**Thames Farm Proposed Development – Environmental Impact Assessment
(EIA) Screening Application
- P24/S1613/SCR**

**TFAQ comments on the completion of the proforma EIA Screening Matix &
Application Documents**

JBA Project Code	2020s1712
Contract	Review of Drainage Strategy for Thames Farm, Shiplake
Client	Shiplake Parish Council
Date	January 2021
Author	Brendon McFadden
Reviewer / Sign-off	Susan Wagstaff
Subject	Hydrogeological review of drainage proposal

Figure 4-1 - Site footprint in relation to groundwater abstraction borehole SPZ

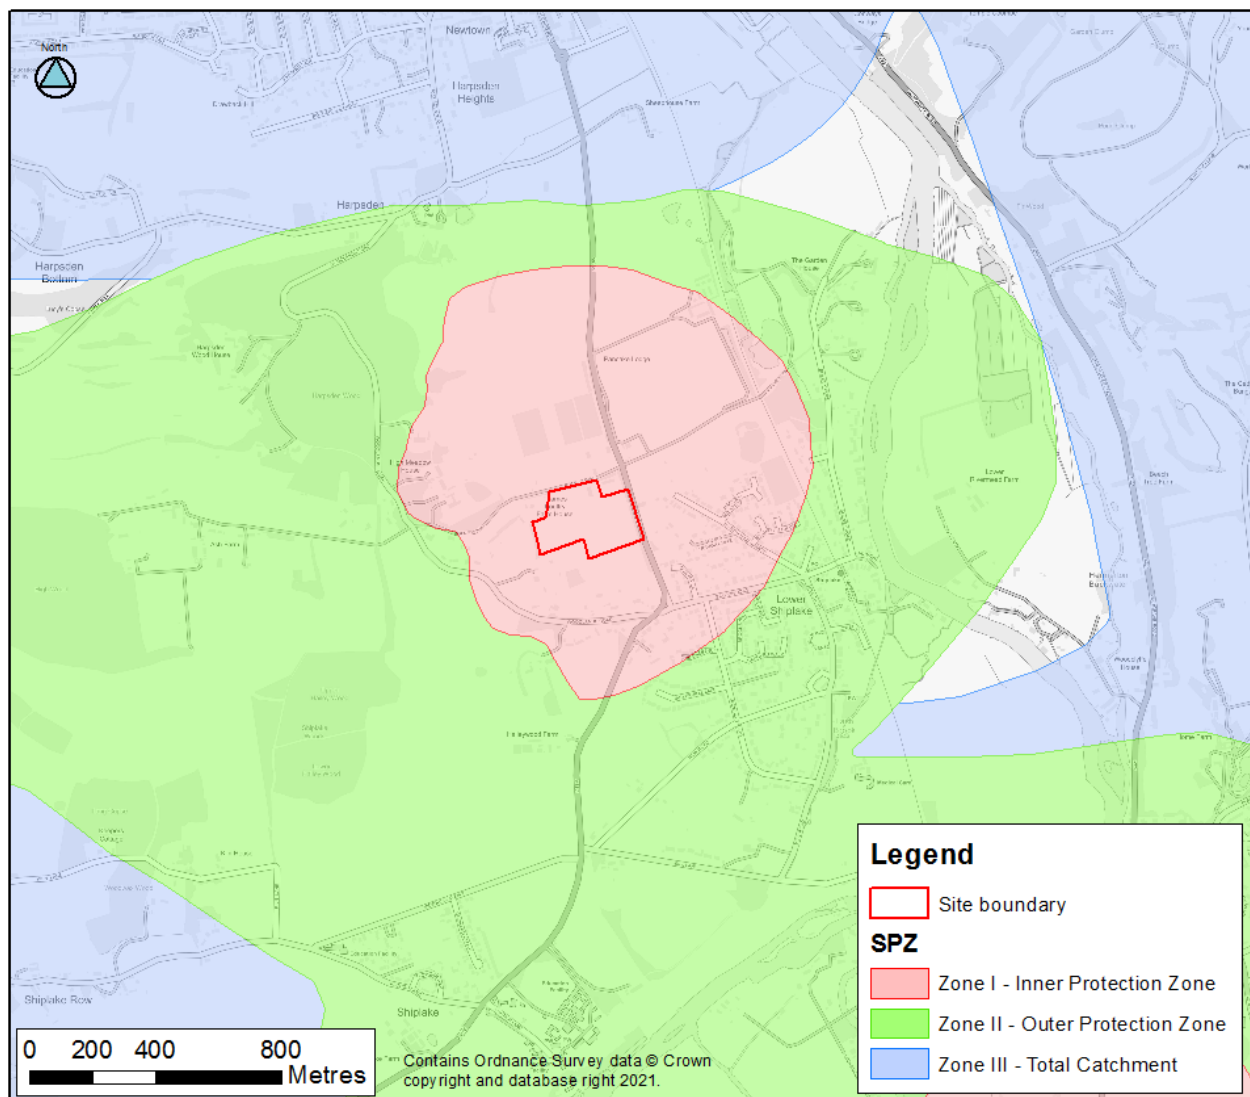
It is noted that the report does not use the most up to date SPZ mapping (see latest SPZ outlines in Figure 4-1).

- Increase the likelihood of the borehole being affected by pollution incidents,
- Put new SPZ 1 restrictions on the uses of parcels of land formally not subject to them, reducing their potential utility. This also relates to Policy ENV12 detailed above, which states that there should not be significant adverse impacts on the amenity of neighbouring uses. The SPZ 1 area is approximately 1,280,000 m² while the site footprint is 57,300 m² (see Figure 4-1), which is approximately 4.5% of the SPZ 1 area.

The current HIA (including deep borehole soakaways) assumes that recharge to the PWS would likely increase and be quicker with the proposed development. However, as the newly proposed drainage plan excludes all infiltration mechanisms it would be necessary to reassess the potential effect of removing nearly all recharge across the site, and alteration of the SPZ 1, in an updated HIA.
